# **CONNECTION ASSESSMENT & APPROVAL PROCESS**

## ***PRELIMINARY ASSESSMENT REPORT***

*For Phase I of the Proposed Development near Tilbury by AGSTAR Power Inc.*

*CAA ID No. 2000-023:*

Options available for Incorporating Phase I of the AGSTAR Project

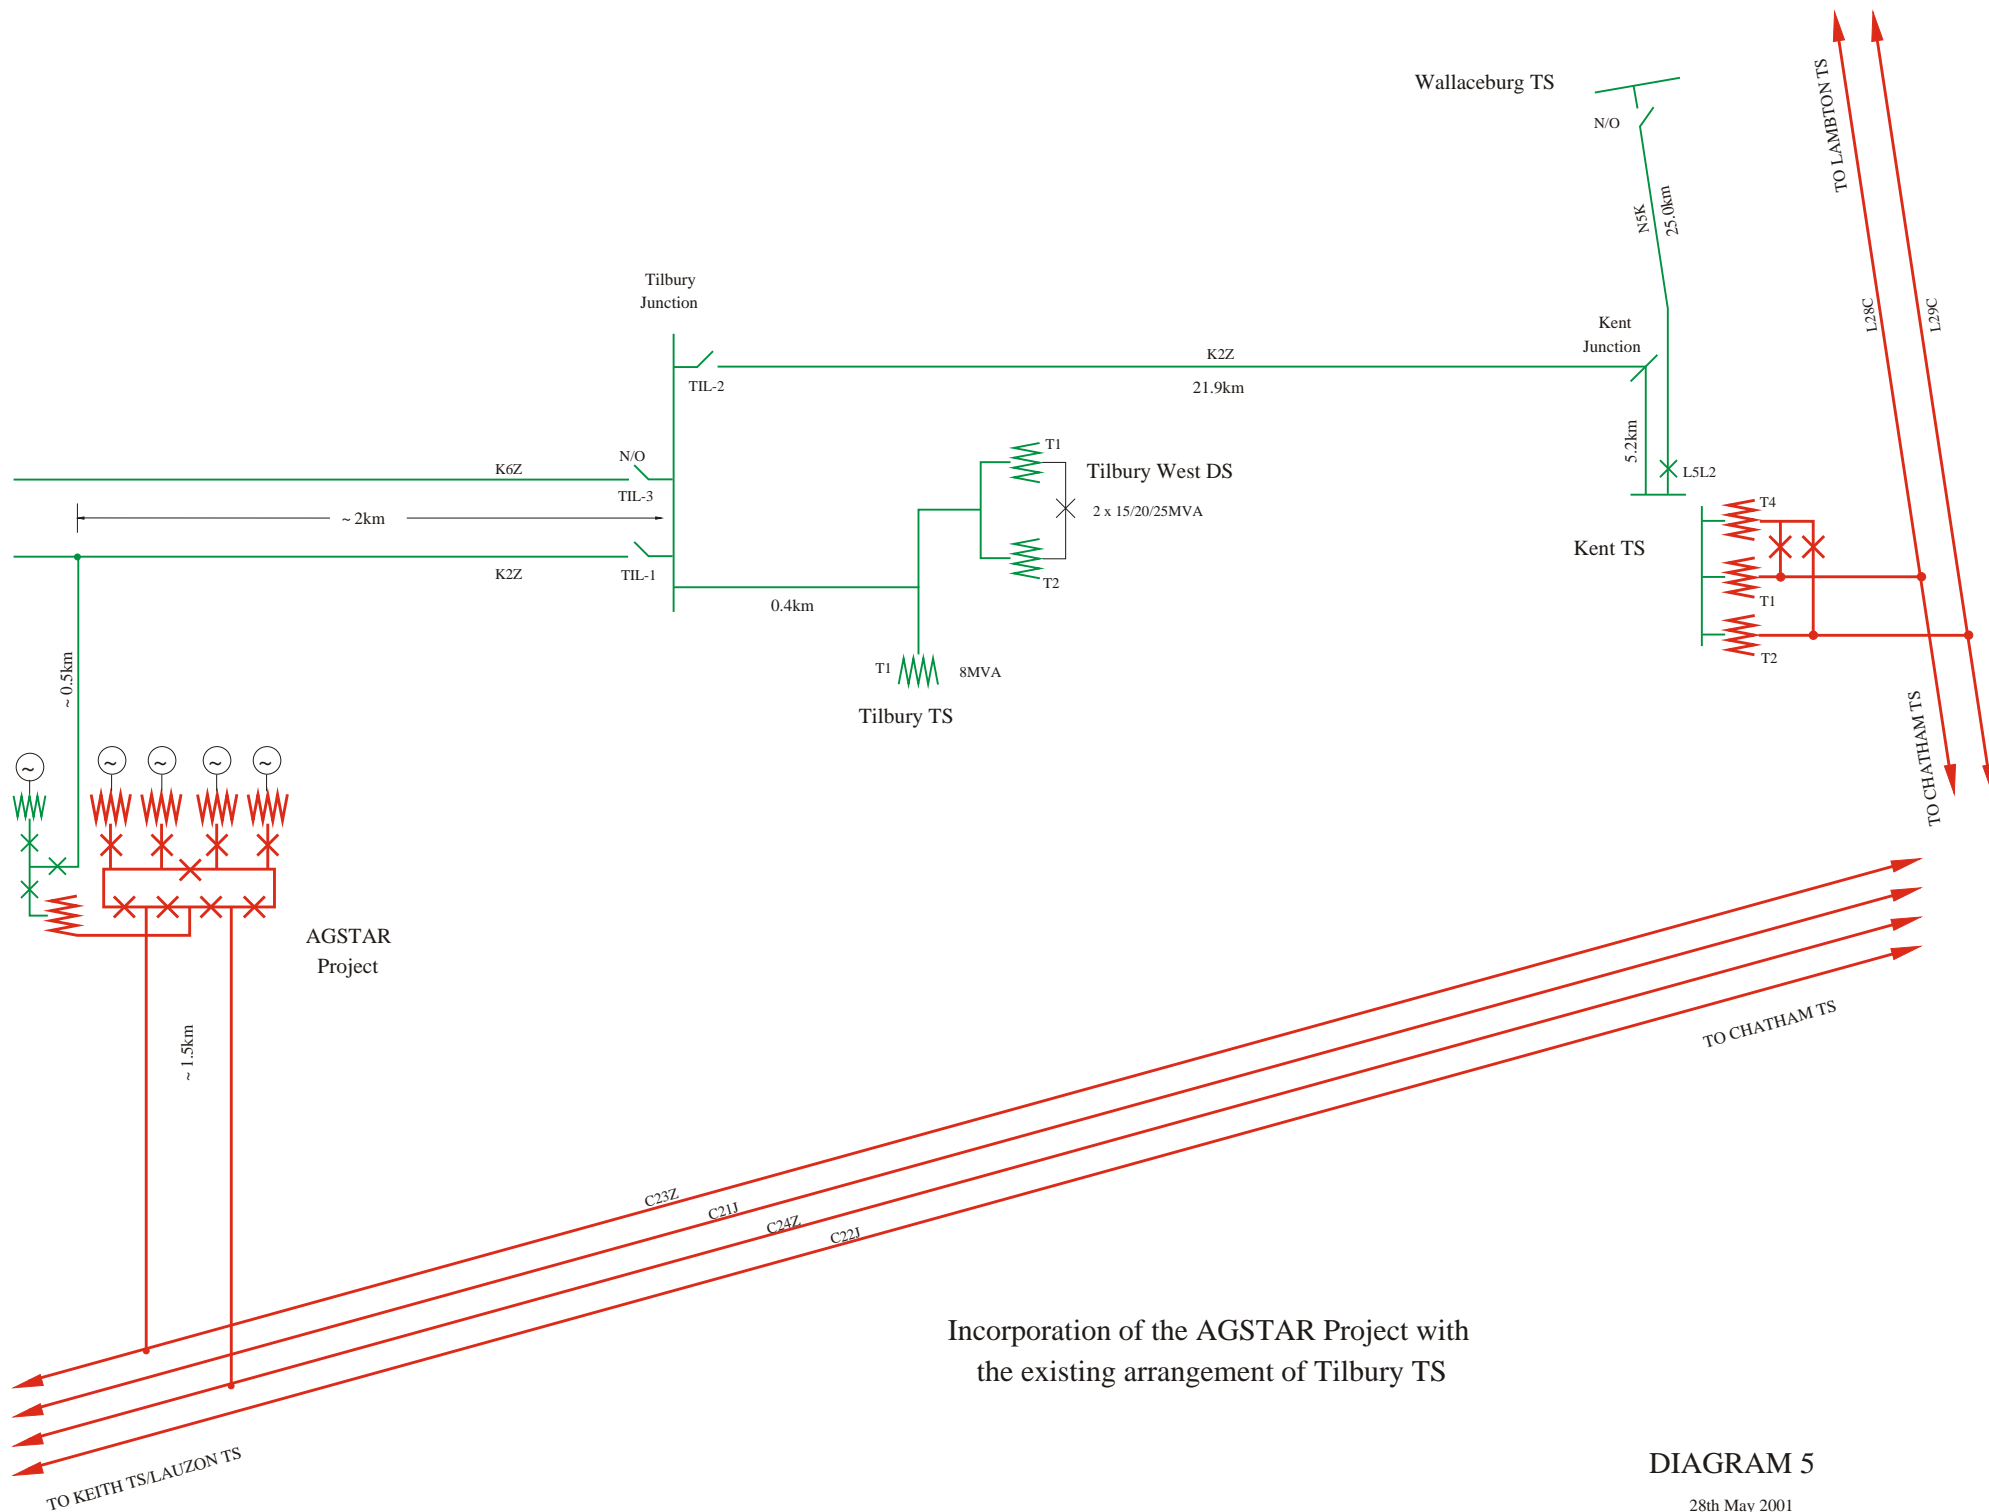
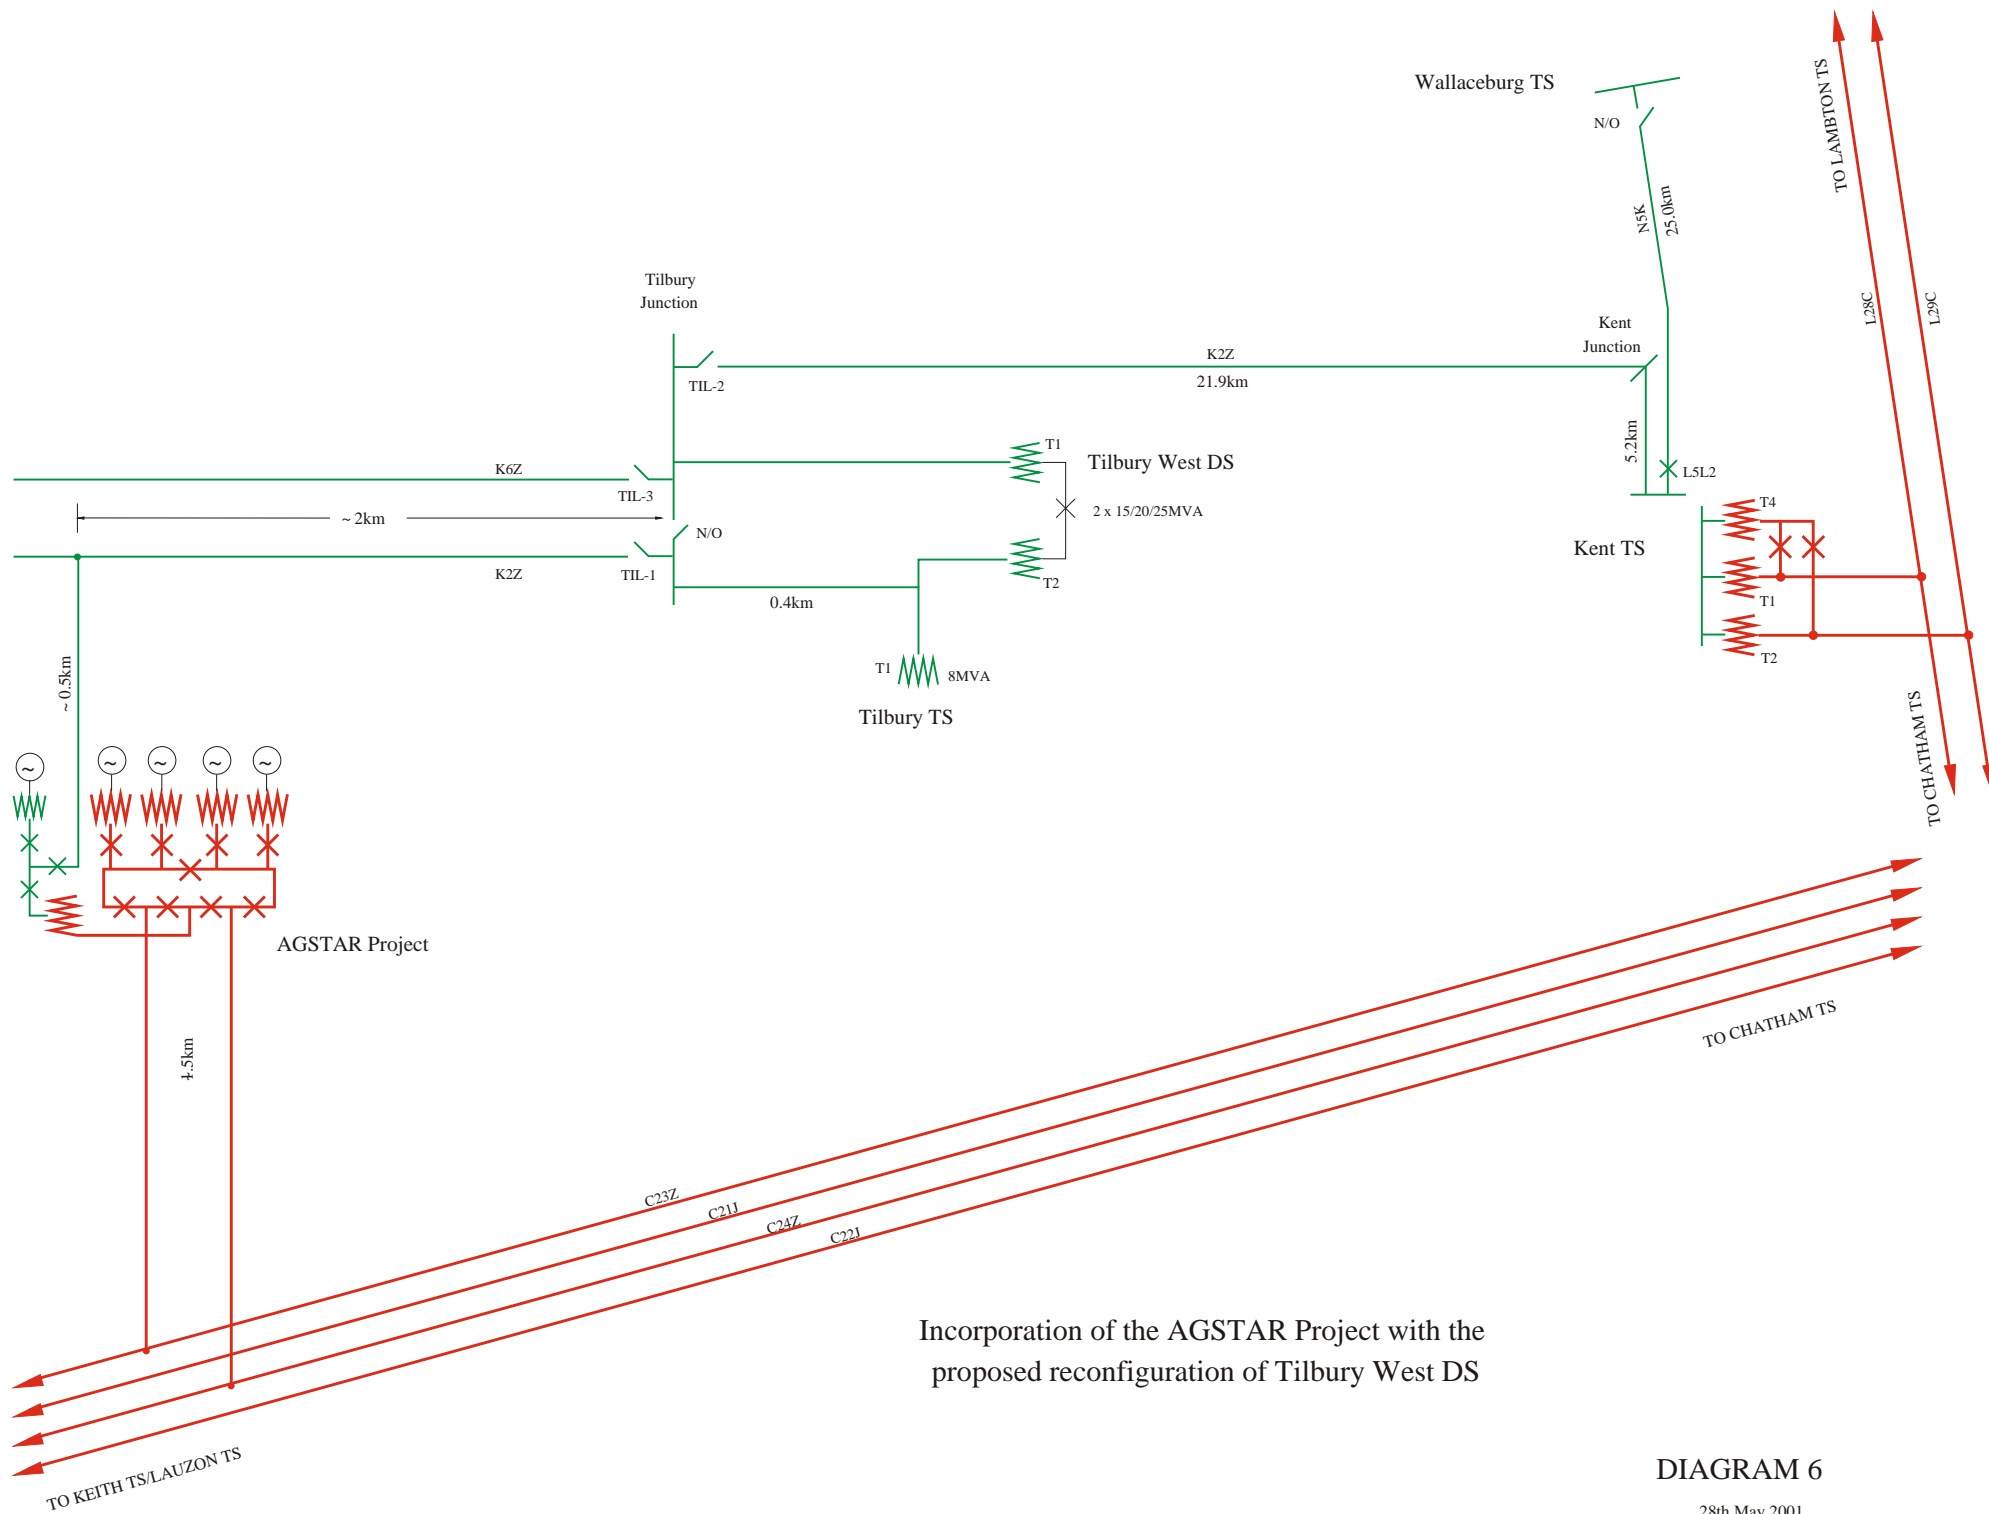
However, should AGSTAR Power Inc. elect to employ an HV breaker for synchronising their 115kV generating unit, then the preferred arrangement that would provide greater operational flexibility, particular during outages for maintenance, is shown in Alternatives 2.1 & 2.2. These latter two arrangements would require the two ‘synchronising’ breakers to be capable of withstanding voltages of 2 pu across their open terminals during the synchronising period.

The arrangement shown in Alternative 2.1 would require a connection from the AGSTAR Project to circuit K6Z, and a normally-open point to be maintained at Tilbury Junction. The arrangement shown in Alternative 2.2 would require the normally-open point to be moved to the location at which the AGSTAR Project is connected to the 115kV system. Both incorporation circuits could therefore be terminated on to circuit K2Z, on either side of the new normally-open point. The shorter connection (on to circuit K2Z rather than to circuit K6Z) would have the added benefit of avoiding the need for a disconnect switch to be installed at the connection point to allow isolation of the incorporation circuit in the event of a permanent fault.

Furthermore, since the 115kV busbar at Tilbury Junction would need to be operated normally-open (to allow Tilbury West DS to be operated as a DESN), Alternative 2.2, as shown in Diagram 4, would no longer be a viable option. With the 115kV busbar at Tilbury Junction operated normally-open, it would no longer be possible to establish a connection to circuit K6Z via this 115kV busbar.

*The arrangement shown in Alternative 2.1, which would allow the 115kV busbar at Tilbury Junction to be operated normally-open while also addressing the concerns regarding unbalanced loading and circulating reactive power through the step-down transformers at both Tilbury West DS and Kingsville TS, would therefore represent the preferred arrangement.*

It is therefore recommended that the design of those facilities in Phase I of the AGSTAR Project should allow for its future development into the arrangement shown in Alternative 2.1.

THREE-PHASE FAULT on 115kV circuit K2Z at Tilbury Junction - Cleared Normally:

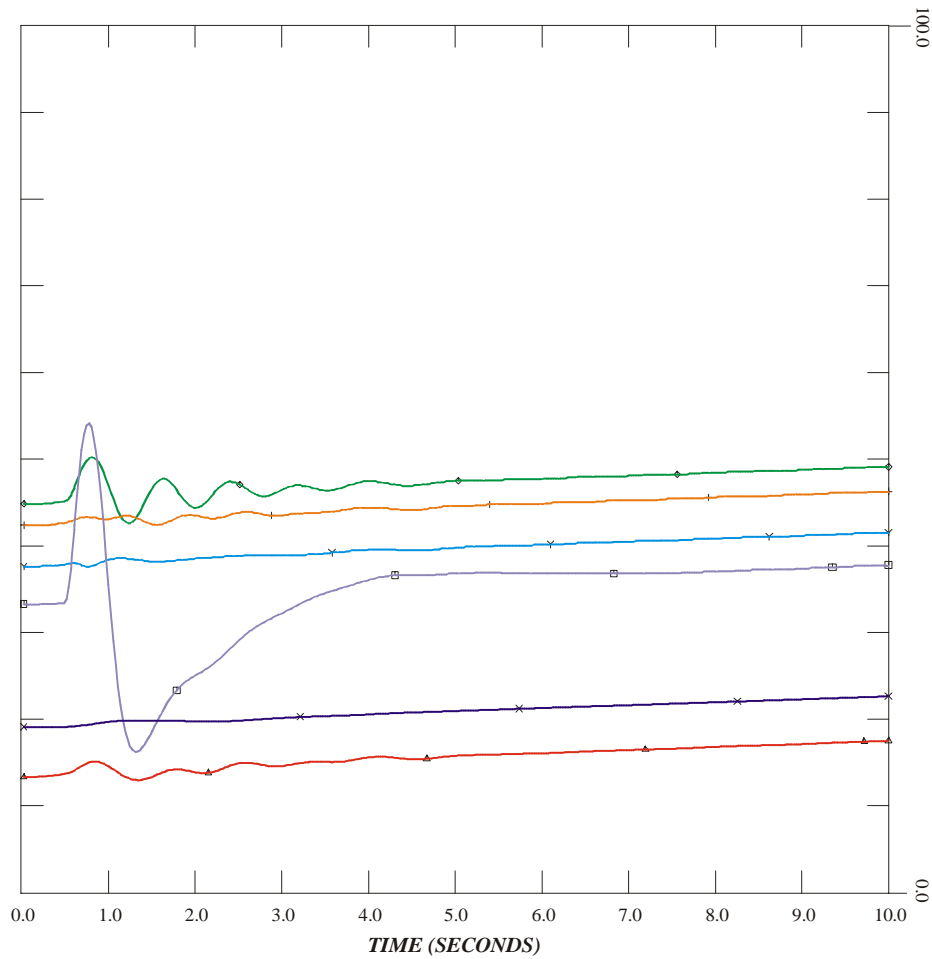
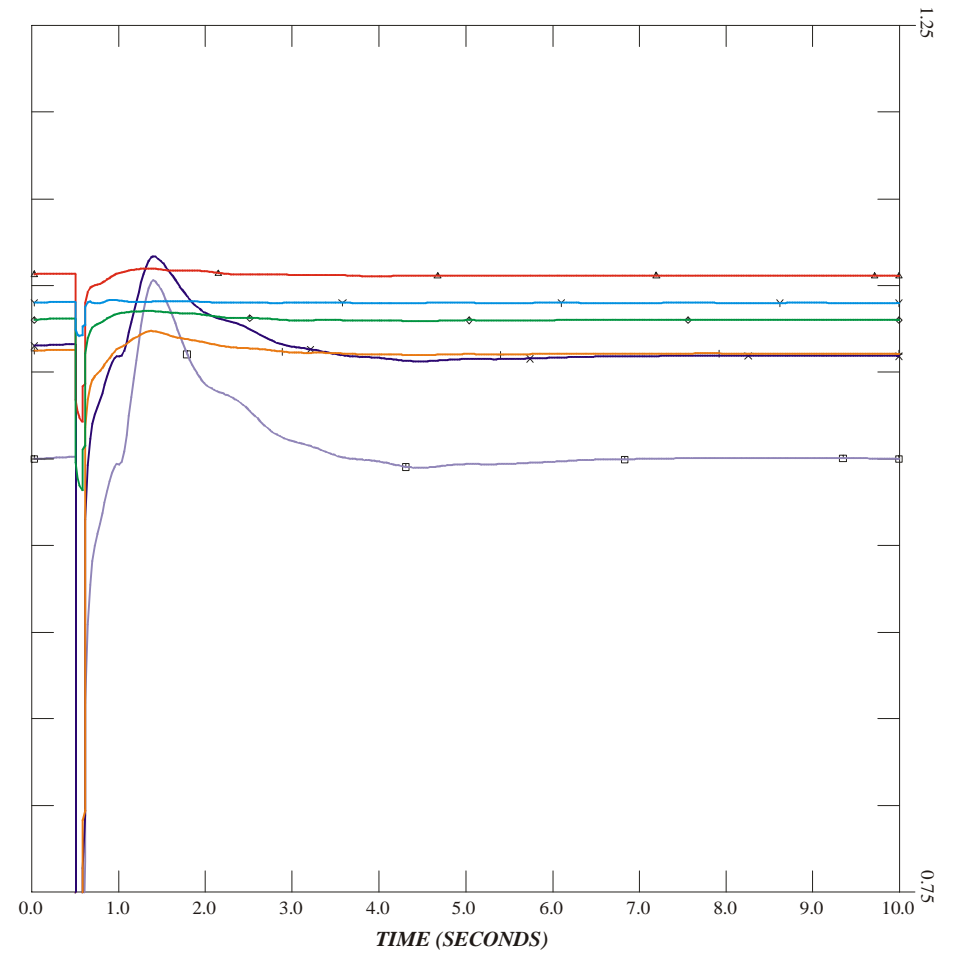
The results for studies 1, 2 & 4 are shown in Diagrams 9, 10 & 11, respectively.

Examination of Diagrams 9, 10 & 11 shows that while the AGSTAR generator remained stable for all the contingency conditions that were examined, the response is rather unusual. This may be the result of the actual data that were provided for the exciter and/or the power system stabiliser, or of the data conversion process.

It is therefore a requirement of the IMO that further transient stability studies be performed once the equipment design is finalised and more definite data are available, to confirm the acceptability of the transient performance.

DOUBLE-CIRCUIT THREE-PHASE FAULT on 230kV circuits C23Z & C24Z at Lauzon TS - Cleared Normally:

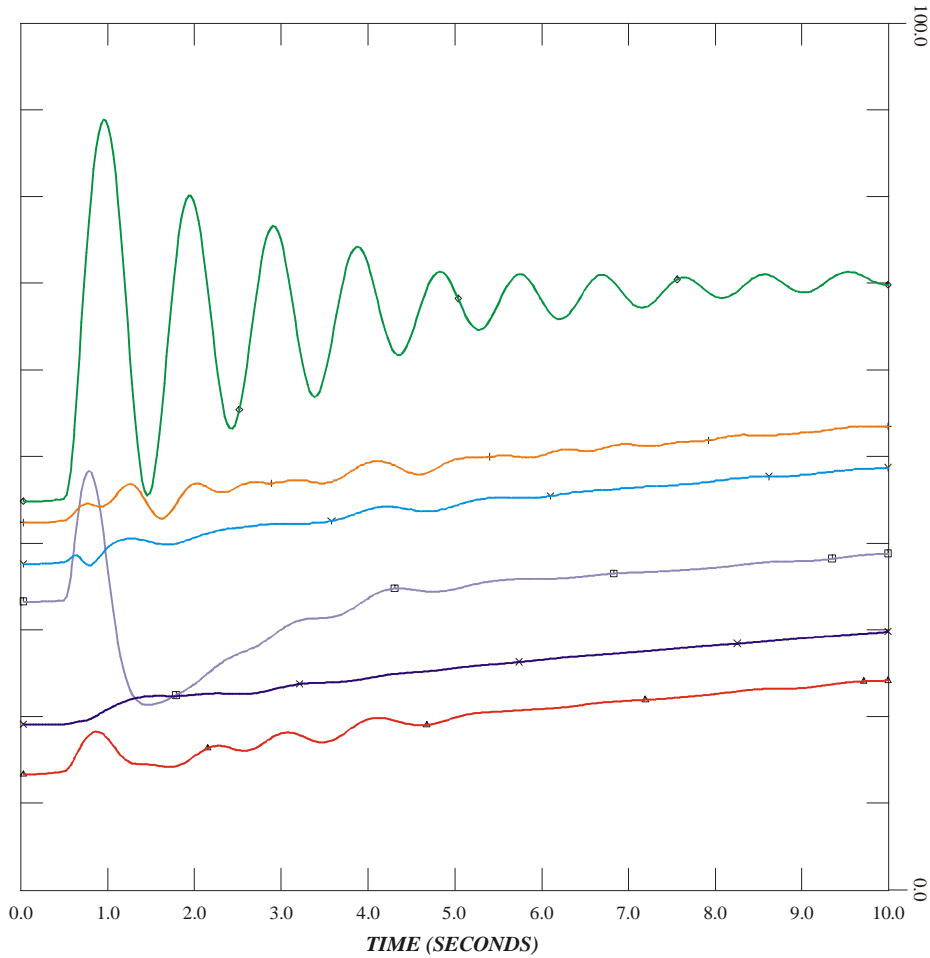
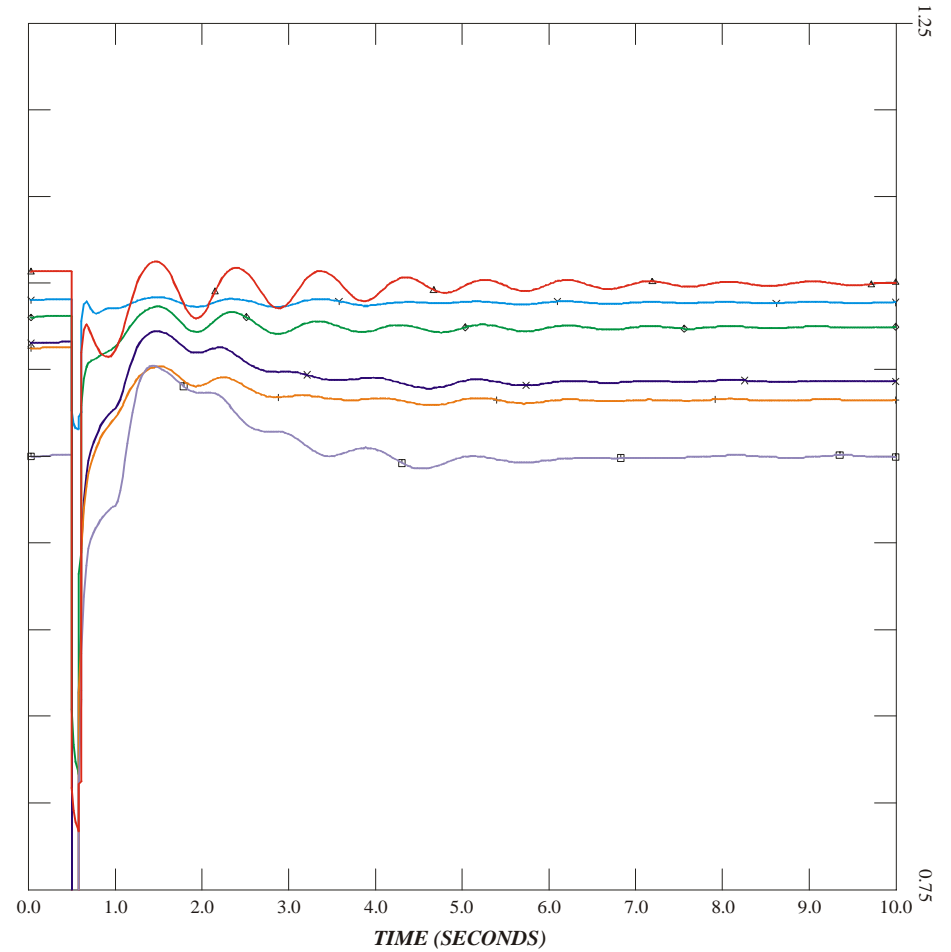
It is worth noting that in Study 4 (Diagram 11), that simulated a double-circuit fault on the 230kV circuits C23Z & C24Z at Lauzon TS, that was cleared normally, the AES facility was deliberately retained in-service post-contingency via the section of circuit C24Z between Chatham TS and the tapping point of the AES Project. The AES Project was therefore allowed to remain in-service via a single, radial 230kV connection to Chatham TS. While this situation would not arise in practice (because the incorporation arrangement for the AES Project does not include any breakers at the tapping point), it was done to allow the relative responses of the AES & AGSTAR Projects to be compared.
